PROJECT NAME:	NEWFANE	PLOT DATE:	22-OCT-2012
PROJECT NUMBER:	BRF 0106 (3)S	DRAWN BY:	C. MOONEY
FILE NAME:	s95j280xs.dgn	CHECKED BY:	G. SWEENEY
PROJECT MANAGER:	C. CARLSON	ROADWAY CROSS SECTIONS I	SHEET 47 OF 70
DESIGNED BY:	T. LACKEY

STA. 1+030 TO STA. 1+060

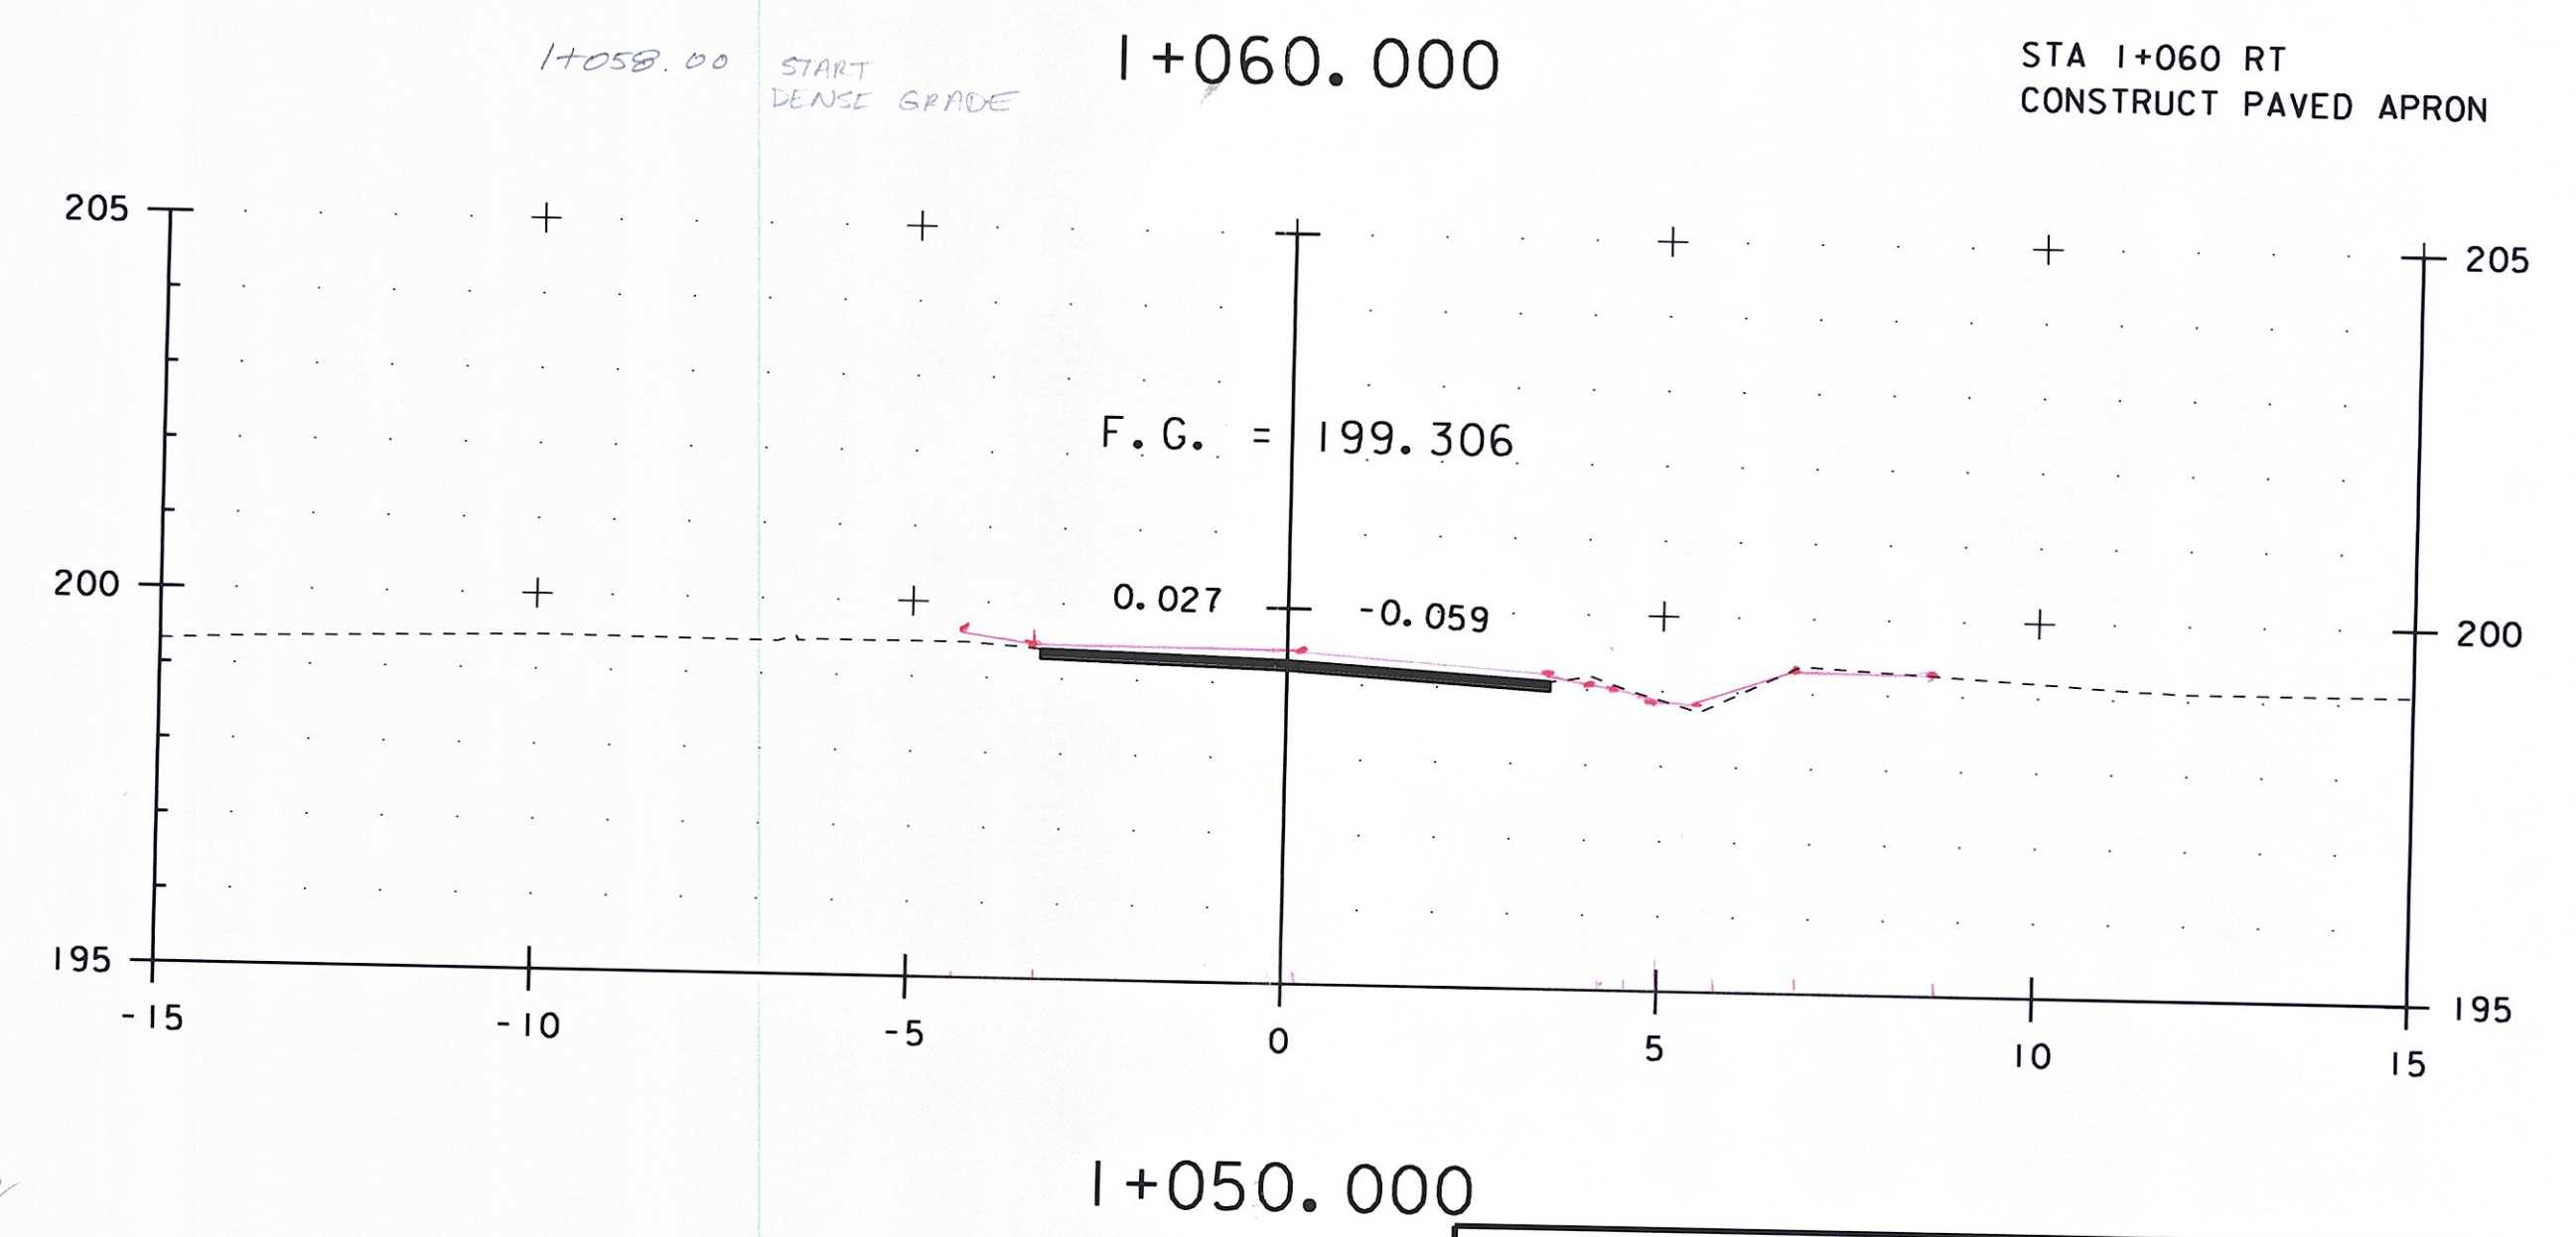
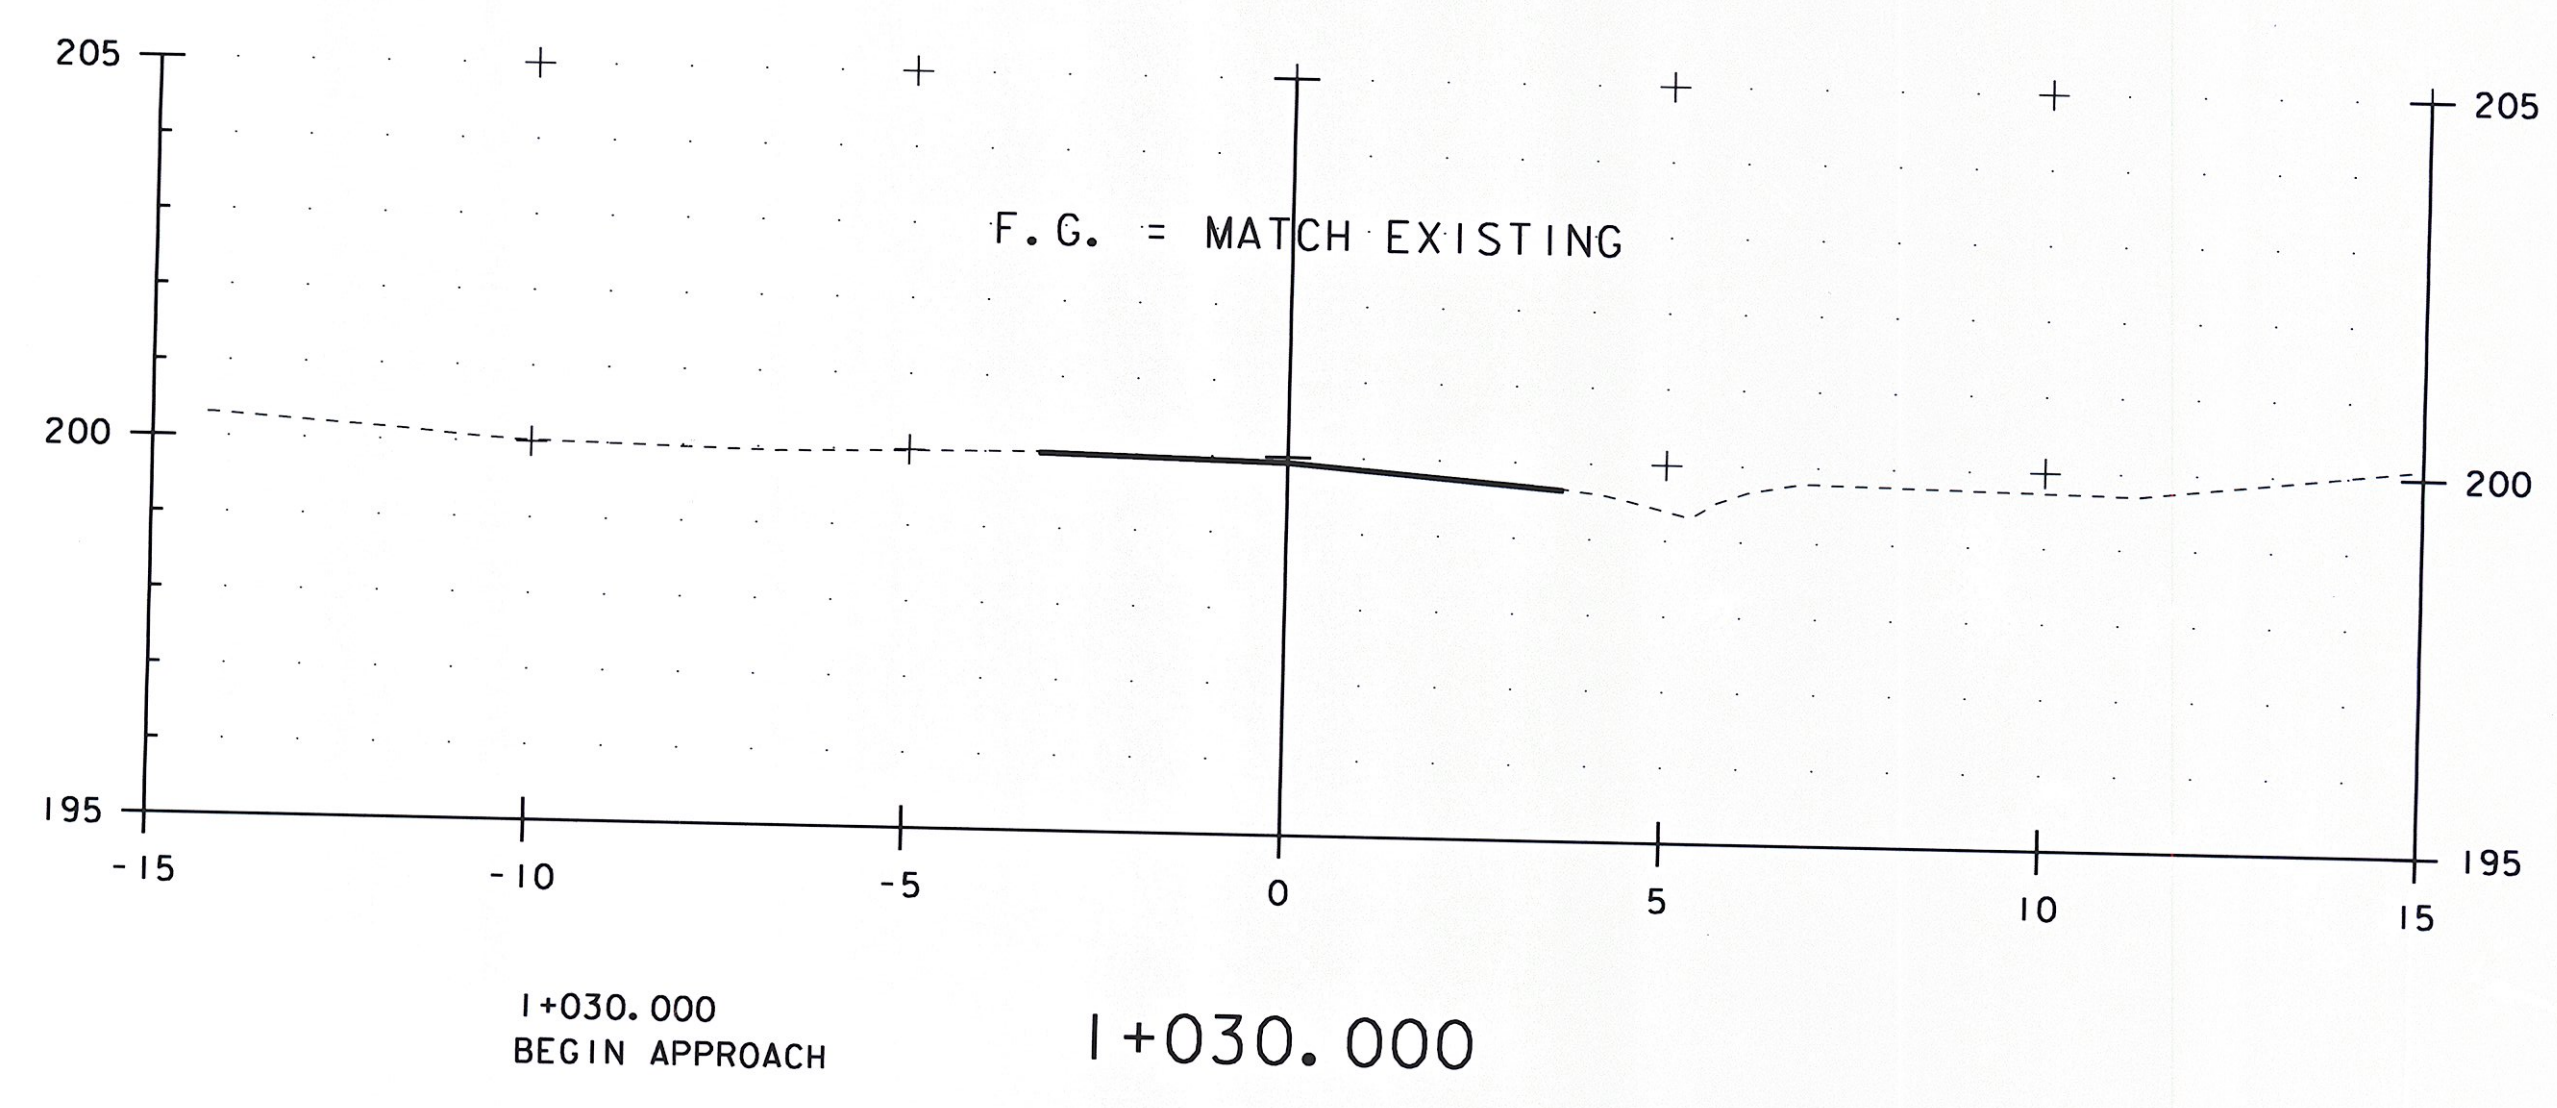
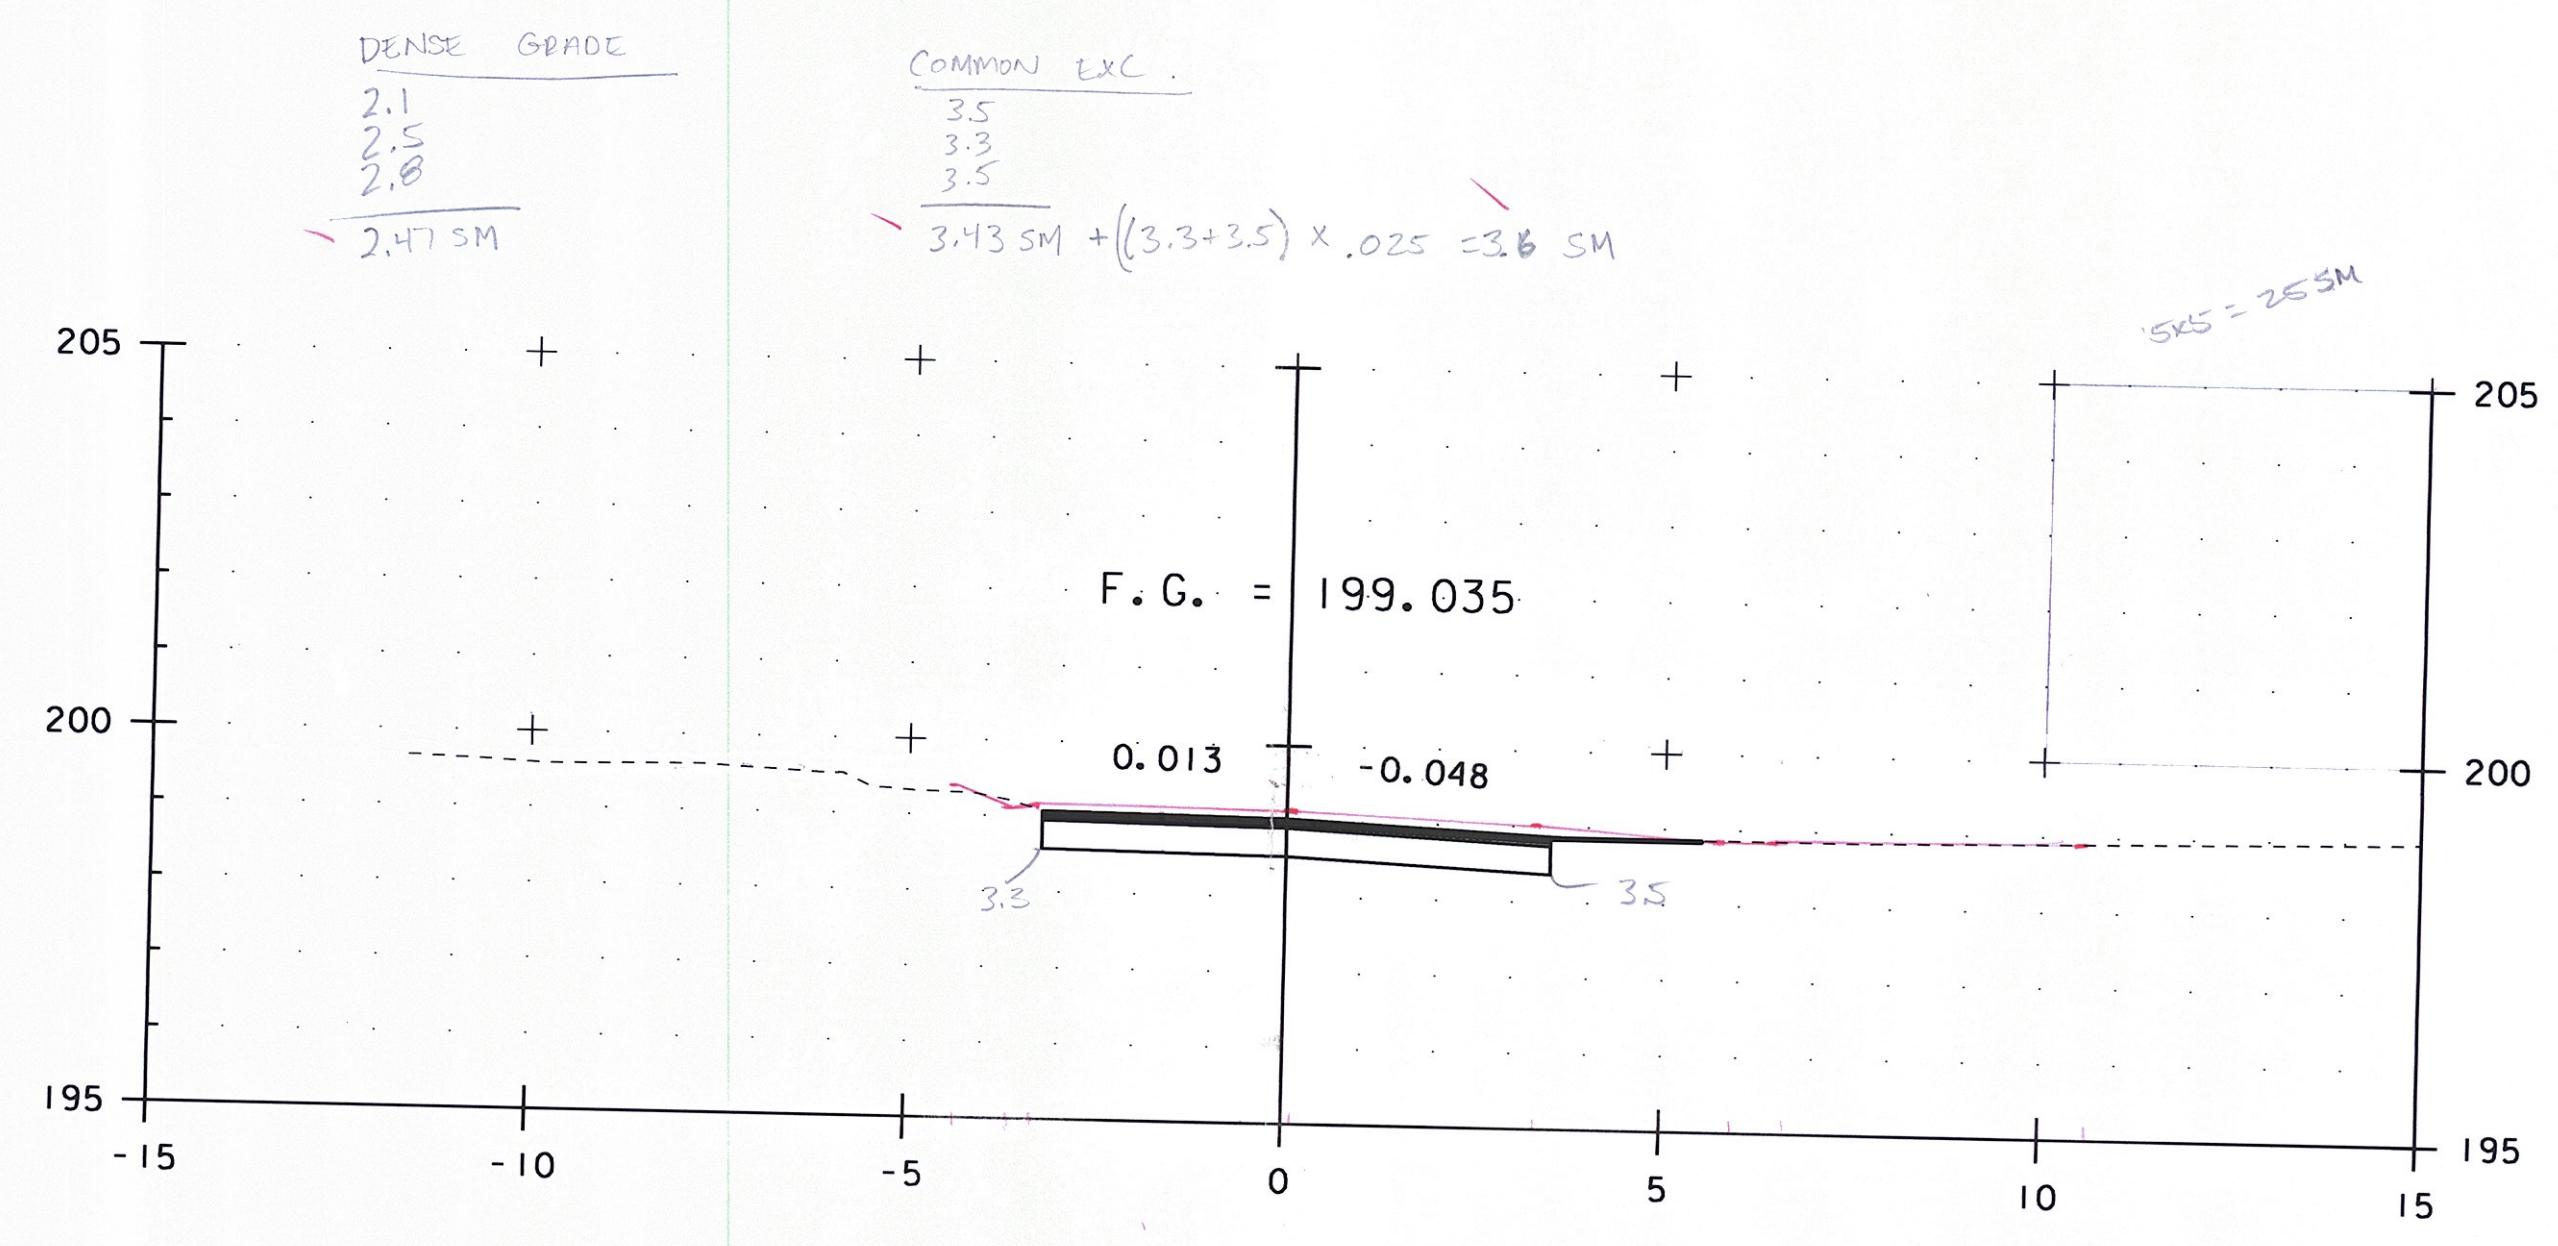
\* ADD 25 mm x width of cut to common excavation to account for added pavement depth.  
 Dense grade and sand stay the same
